**Reference: 750 Old Highway 24 – Site Plan Application – Phase 1 Submission 2  
Verlinda Homes, Waterford, Norfolk County  
Our Project 20-128**

G. Douglas Vallee Limited is the agent acting on behalf of Verlinda Homes regarding a site plan application with Norfolk County. Please accept this package as our formal second site plan application for a commercial / retail development located at 750 Old Highway 24 in Waterford.

Project Title: **ORCHARD SQUARE**  
WATERFORD, NORFOLK COUNTY

Drawing Title: **SERVICING PLAN**

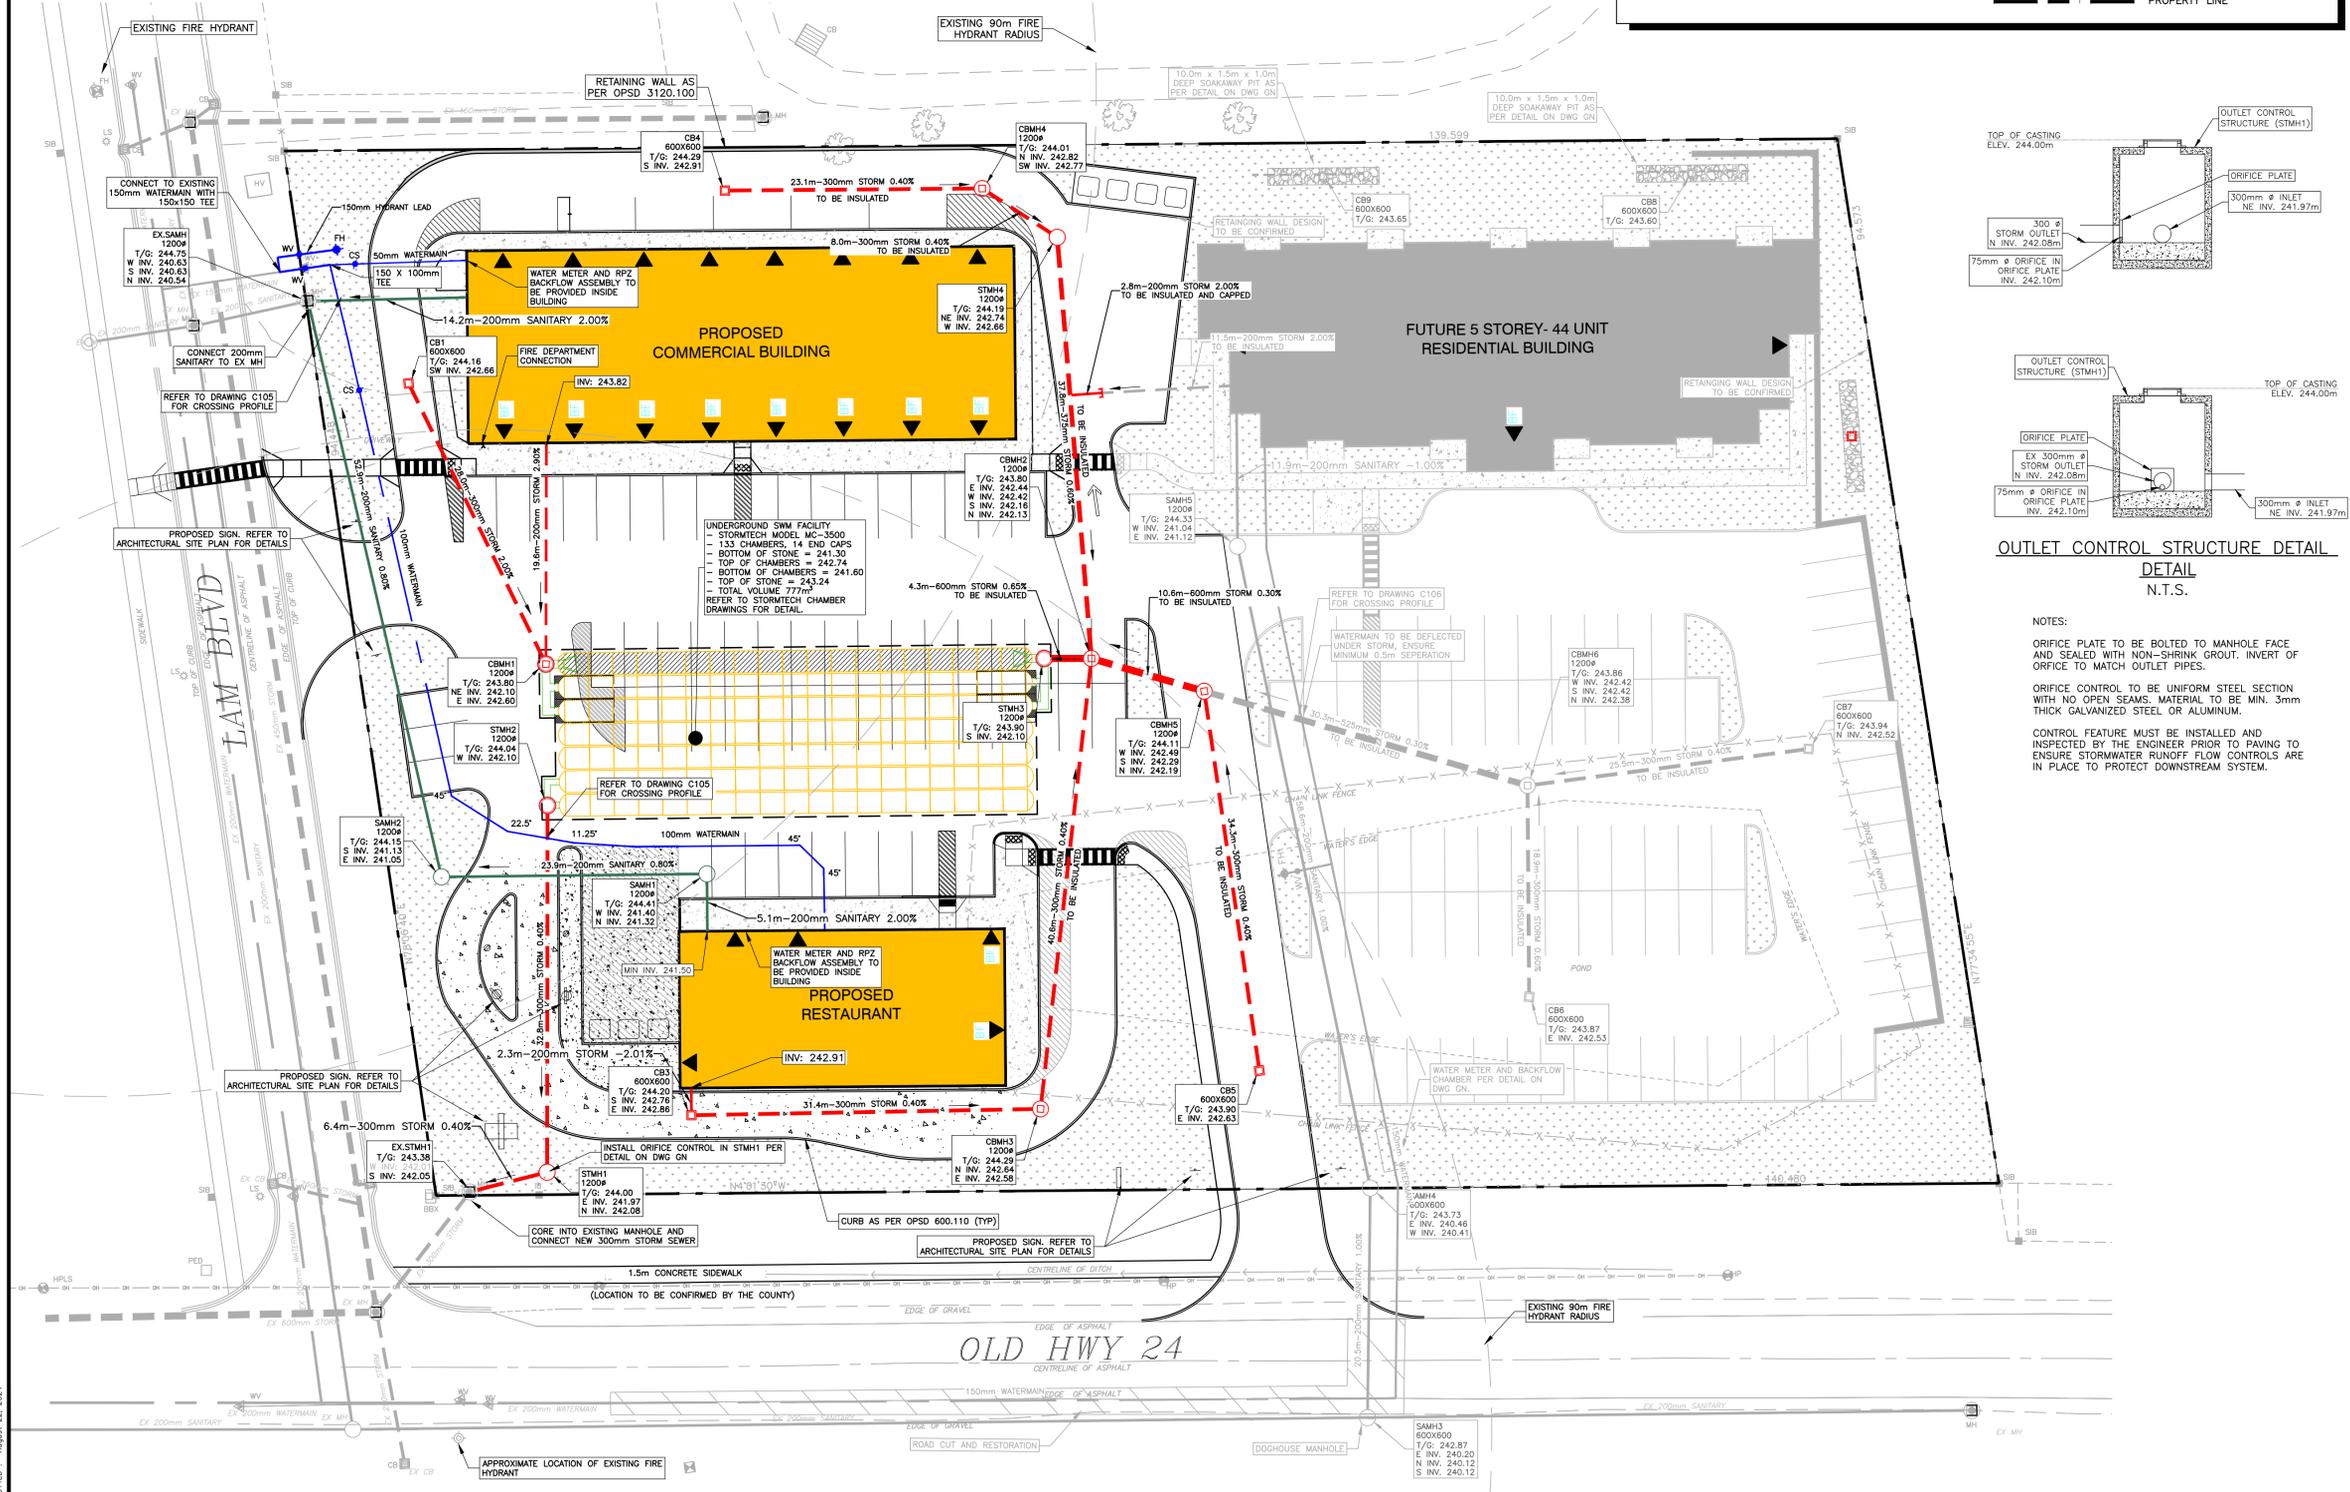
1st Submission	Development Engineering Servicing Plan DWG C101	11	15-Jul-24	Existing (and proposed) property lines and easements are to be shown.	Coordinate with drawing A101B Site Plan.	Vallee - Architecture	Complete
1st Submission	Development Engineering Servicing Plan DWG C101	12	15-Jul-24	Add a crossing detail at the crossing of the 200mm proposed sanitary pipe and the 200mm proposed watermain.	There is no crossing of a proposed 200mm sanitary and a proposed 200mm watermain. A crossing detail of the Phase 1 water service and the commercial building 200mm sanitary service is from on Drawing C105 which shows adequate vertical separation.	Vallee - Civil	Complete
1st Submission	Development Engineering Servicing Plan DWG C101	13	15-Jul-24	Match the valve symbol to the one shown on Drawing GN.	Noted. The valve symbol has been corrected to match Drawing GN.	Vallee - Civil	Complete
1st Submission	Development Engineering Servicing Plan DWG C101	14	15-Jul-24	Specify the materials of all pipes.	All pipe materials are noted on Drawing GN.	Vallee - Civil	Complete

1st Submission	Development Engineering Servicing Plan DWG C101	15	15-Jul-24	The Domestic water service cannot be taken off the Hydrant lead. The Domestic service must be taken off in the ROW and a domestic valve installed at Property line. A sketch received by Environmental Services is attached at the end of these comments. Please contact Development Engineering if you have any questions.	Noted. The hydrant and water service layout has been revised per the sketch provided by Norfolk County.	Vallee - Civil	Complete
1st Submission	Development Engineering Servicing Plan DWG C101	16	15-Jul-24	In consultation with Norfolk County Environmental Services department, it has been determined that the Backflow Chamber will not be required for Phase 1 of this development. The water meters and RPZ assemblies will be installed inside the buildings. Consultation with Environmental Services to determine the configuration is recommended prior to building permit application.	Noted. The Servicing Plan has been updated to reflect this requirement.	Vallee - Civil	Complete

1st Submission	Development Engineering Servicing Plan DWG C101	17	15-Jul-24	At all proposed crossings, note inverts/obverts and/or show profile of crossing. Separation distances between all services has to be noted on the plan and any separation conflict clearances has to be labelled. Plan and Profile drawings are required as per Section 16.4.03 of Norfolk County Design Criteria.	All proposed crossings are shown Drawing C105, which shows adequate vertical separation at all crossings.	Vallee - Civil	Complete
1st Submission	Development Engineering Servicing Plan DWG C101	18	15-Jul-24	It is unclear the purpose of placing a new Storm lateral within the Municipal ROW when an existing lateral and property line manhole already exists. Old Hwy 24 was recently paved, and it would be preferred to limit future road cuts if possible. If there is a known issue with the existing Storm infrastructure, please identify it in your next submission.	Noted. The design has been revised to utilize the existing storm manhole at the northwest corner of the development.	Vallee - Civil	Complete

1st Submission	Development Engineering Servicing Plan DWG C101	19	15-Jul-24	As shown in this drawing the future Residential building has a Storm connection to the neighboring property in a separate location than the parking lot. Prior to approving this connection location Development Engineering will require confirmation that the Shared Facilities Agreement acknowledges multiple connections to the shared Storm system.	Noted.	Vallee	Complete
1st Submission	Development Engineering Grading Plan DWG 102	20	15-Jul-24	All manholes, catchbasins, sidewalks, parking space line painting, etc. to be labelled or shown in legend with existing or proposed identification (labels, line types, etc.).	All manholes, catchbasins, valves and curb stops are labeled on C101. All sidewalks, parking space line painting, etc are shown on Drawing A101B Site Plan and A102 Site Plan Details.	Vallee	Complete

Drawing Title  
**GRADING PLAN**

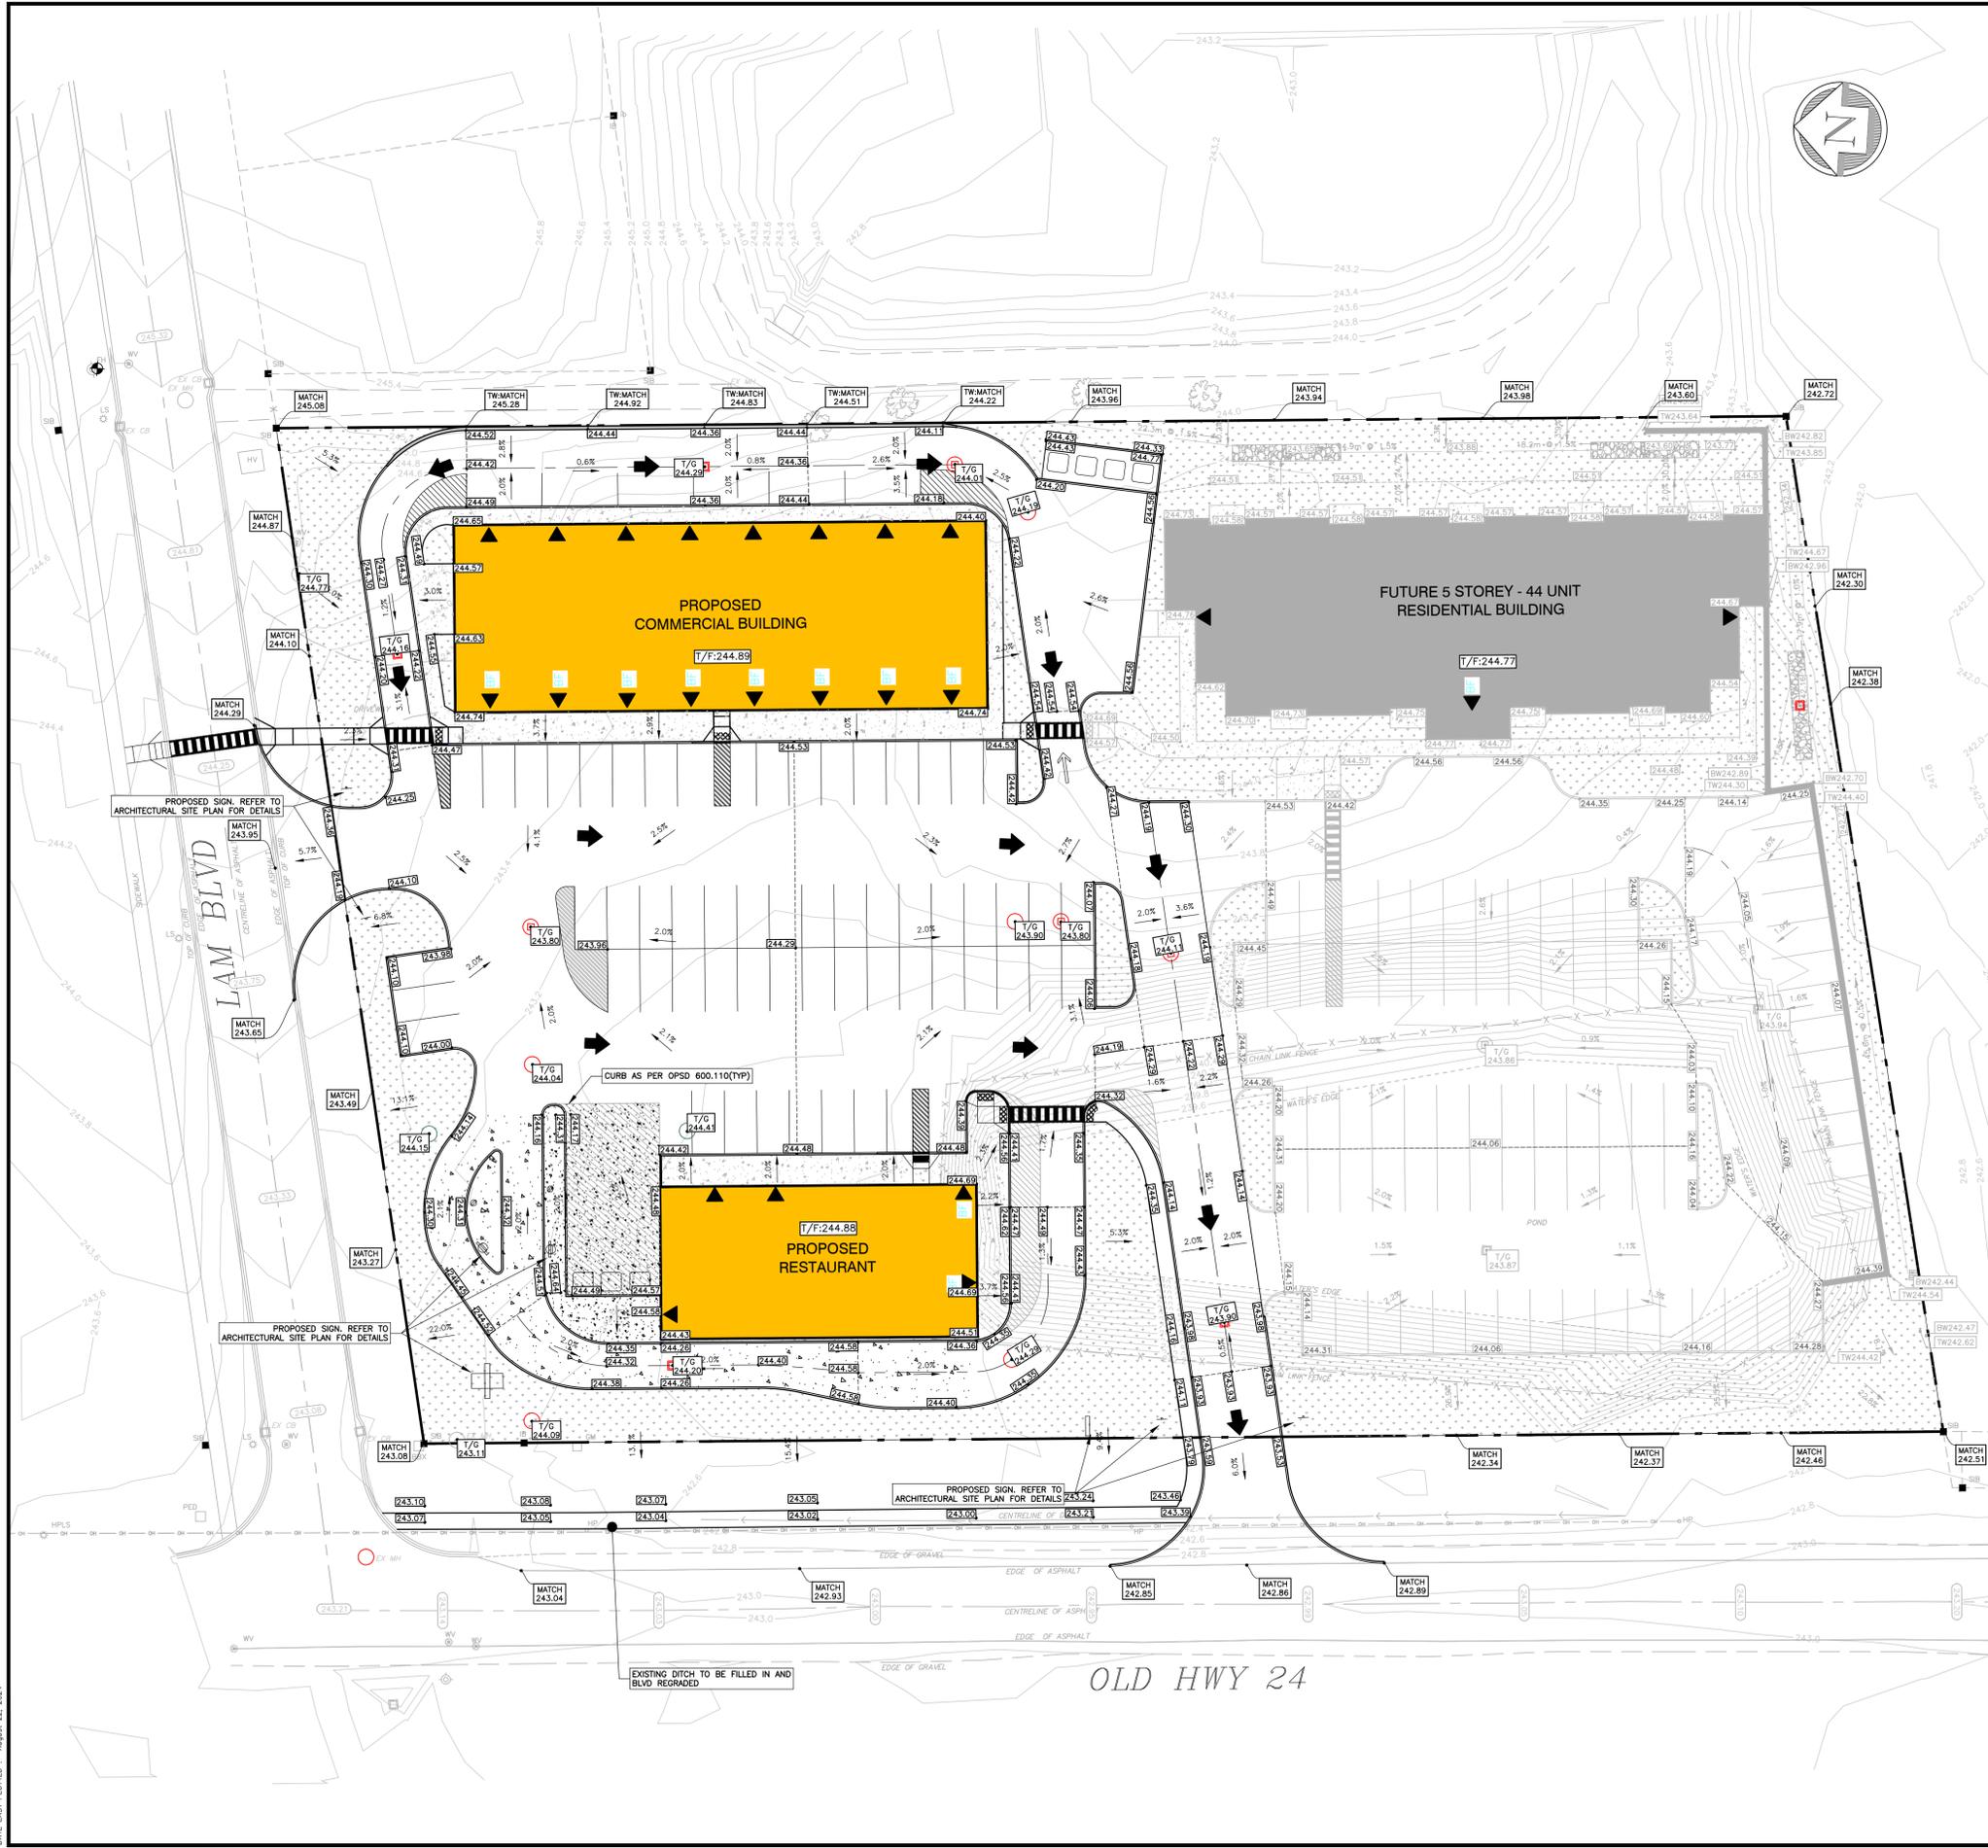
1st Submission	Development Engineering Grading Plan DWG 102	21	15-Jul-24	In the plan, provide the arrow in the legend depicting emergency overland flow direction. Please show Emergency Overland Flow directions.	Noted. Emergency overland flow direction arrows have been added to the plan.	Vallee - Civil	Complete
1st Submission	Development Engineering Grading Plan DWG 102	22	15-Jul-24	Specify and label tactile plates where needed.	Coordinate with drawing A101B Site Plan.	Vallee - Architecture	Complete
1st Submission	Development Engineering Grading Plan DWG 102	23	15-Jul-24	At the entrances, provide grade break elevations and slopes as per 16.5.01. Also, provide elevations of the existing edge of asphalt.	Noted. Elevations and slopes are shown at all entrances, including the existing edge of asphalt elevation.	Vallee - Civil	Complete
1st Submission	Development Engineering Grading Plan DWG 102	24	15-Jul-24	Add elevations for top grade of proposed sanitary manholes.	Noted. Top of casting elevations have been shown on all sanitary manholes.	Vallee - Civil	Complete

1st Submission	Development Engineering Grading Plan DWG 102	25	15-Jul-24	Add OPSD standards for curb and sidewalk. Similar to what is shown on Arch drawings or just reference them.	Coordinate with drawing A105 and A105A OPSD Details.	Vallee - Architecture	Complete
1st Submission	Development Engineering Grading Plan DWG 102	26	15-Jul-24	An area rough grading plan is required as the earth fill exceeds 0.5m as per 11.6.01.	Noted. An excess cut and fill drawing has been created.	Vallee - Civil	Complete
1st Submission	Development Engineering Grading Plan DWG 102	27	15-Jul-24	The existing ground contour to be extended 30m beyond the property limits to indicate the grading and drainage pattern of the adjacent land as per 16.4.02.	Noted. The viewport has been extended to show contours 30m beyond the property limits.	Vallee - Civil	Complete
1st Submission	Development Engineering Grading Plan DWG 102	28	15-Jul-24	Add roadway/driveway dimensions and curb radii.	Coordinate with drawing A101B Site Plan.	Vallee - Architecture	Complete

1st Submission	Development Engineering Grading Plan DWG 102	29	15-Jul-24	Show existing elevations at centerlines of Old Highway24 and Lam Boulevard at 20m intervals as per 16.4.02.	Noted. Existing road centreline elevations have been added.	Vallee - Civil	Complete
1st Submission	Development Engineering Grading Plan DWG 102	30	15-Jul-24	Where a retaining wall is 0.60m or higher, placement of fencing or a guard along the top of the wall is required as per 11.4.00.	A fence is proposed along the top of the retaining wall. Refer to drawing A101B Site Plan.	Vallee - Civil	Complete
1st Submission	Development Engineering Grading Plan DWG 102	31	15-Jul-24	Please add note that all entrances are to be constructed as per OPSD 350.010 or reference the ARCH drawings.	Coordinate with drawing A105A OPSD Details.	Vallee - Architecture	Complete
1st Submission	Development Engineering Grading Plan DWG 102	32	15-Jul-24	This plan shows filling of the ditch along Old HWY 24 to place the required sidewalk. Norfolk County is concerned the existing ditch is an outlet for upstream Strom water. A proper outlet must be identified as upstream storm water will not be permitted to flood onto old HWY 24.	Coordinate with drawing A101B Site Plan. There is a red note that the county is to confirm the location of future proposed sidewalk location. Note that the only water that enters this ditch is from the subject development site and from off Old Highway 24. No up stream storm water from other areas enter this ditch.	Vallee - Civil	Complete

1st Submission	Development Engineering Grading Plan DWG 102	33	15-Jul-24	T/G CB5 is only 3cm lower than the high point in driveway before flows cascade onto Old HWY 24. Please adjust this lid to provide the minimum ponding levels to contain the Major storm events.	All storm sewers have been sized to convey the 100-year storm event, therefore no ponding will occur in major storm events. Refer to the storm design sheet on Drawing STM.	Vallee - Civil	Complete
1st Submission	Development Engineering Grading Plan DWG 102	34	15-Jul-24	Please show 100yr ponding levels in your next submission.	All storm sewers have been sized to convey the 100-year storm event, therefore no ponding will occur in major storm events. Refer to the storm design sheet on Drawing STM.	Vallee - Civil	Complete
1st Submission	Development Engineering Grading Plan DWG 102	35	15-Jul-24	Please note that grading for the future Residential building was not reviewed in detail for this submission. A couple of things to consider for the future development of that site are as follows: i. Revise the swale along the east limit of the property so that Min. slope allowed is 1.5% as per Norfolk County Design Criteria, Section 16.5.01.	Noted. The swale slope has been revised.	Vallee - Civil	Complete
